Access Compliance Report Public Rights-of-Way (Curb Ramps)

Main Street: OMEGA_DR		Cross Street: BROWNING_AVE		Location:	E
ADA ID: RPRK211014115635	Ramp Type: Type 7 - Directional 2	Initial Pass/Fail: Fail	Overall Compliance: No	Severity Score:	2
Codes/Mitigation Info/Possible Solution			Field Measurements/Component Compliance

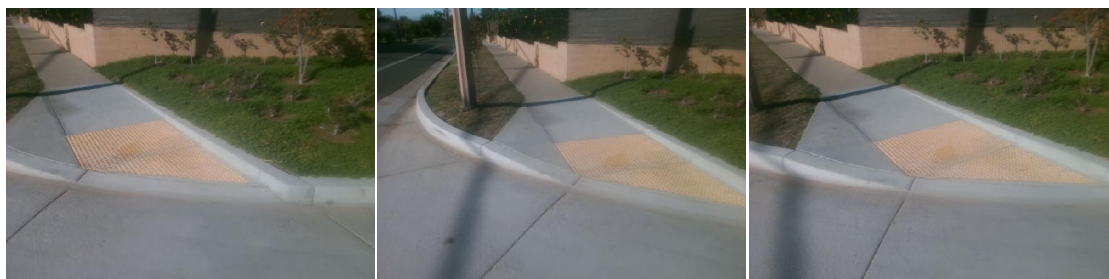
Compliance	Description	Data	Compliance	Description	Data
N/A	Ramp Length (in)	162	N/A	Flare Type LT	
Yes	Ramp Width (in)	48			N/A
Yes	Ramp Run Slope (%)	1	N/A	Flare Slope LT (%)	N/A
No	Ramp Cross Slope (%)	2.8	N/A	Flare Traversable LT	N/A
N/A	Grade Break	Yes	N/A	Flare Type RT	
N/A	Grade Break Slope (%)	1			N/A
N/A	Grade Break Cross Slope (%)	2.8	N/A	Flare Slope RT (%)	N/A
	Addl Para Ramp Left?	No	N/A	Flare Traversable RT	N/A
	Addl Para Ramp Right?	No	N/A	DWS Provided	N/A
N/A	Landing Present	N/A	N/A	DWS Contrast	N/A
N/A	Landing Length (in)	N/A	N/A	DWS Length (in)	N/A
N/A	Landing Width (in)	N/A	N/A	DWS Full Width	N/A
N/A	Landing Run Slope (%)	N/A		DWS Offset Type	N/A
N/A	Landing Cross Slope (%)	N/A	N/A	DWS Left Offset (in)	N/A
N/A	Landing Movement Obstructed?	N/A	N/A	DWS Right Offset (in)	N/A
	Landing Movement Type	N/A			
N/A	Landing Shared	N/A			
N/A	Marked Crosswalk 1	No	N/A	Clear Space	N/A
	Crossing 1 Direction	SW	N/A	Clear Space To Crosswalk (in)	N/A

Remove & Replace Entire Ramp.
